Service Bulletin No.: DAC1-27-02 Rev 1

Title: Flap Actuator Bushing Retainers

Figure 1 – Location of Fastener Holes in Switch Board

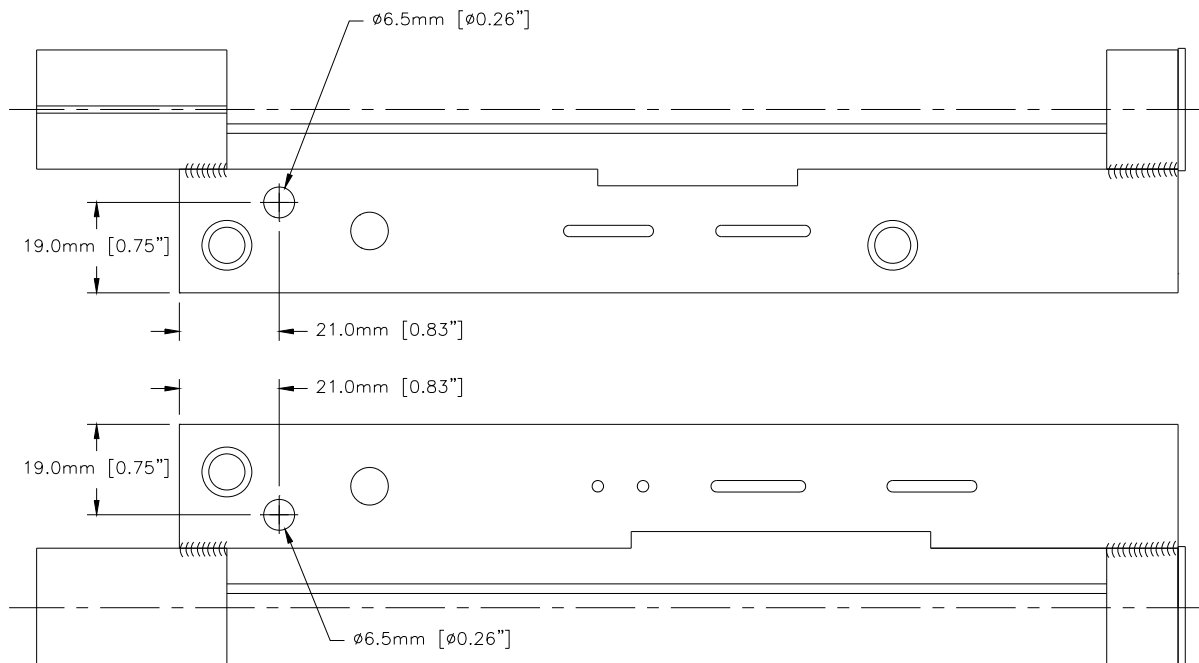
- 10.1 Remove the flap actuator in accordance with AMM Chapter 27-50.
- 10.2 Remove the cover from the flap actuator switch board, retaining the fasteners.
- 10.3 Carefully mark and drill two 6.5mm (0.266") holes in switch board as shown in Figure 1.
- 10.4 Install two 215-082 rivet nuts in 6.5mm diameter holes in same direction as existing rivet nuts. It may be necessary to rotate the switch assembly for access.
- 10.5 Install the flap actuator seal retainers with AN526C832R8 screws and AN960-8 washers into rivet nuts. Locate seal retainers so that they barely touch the seal on the flap actuator as shown in Figure 2.
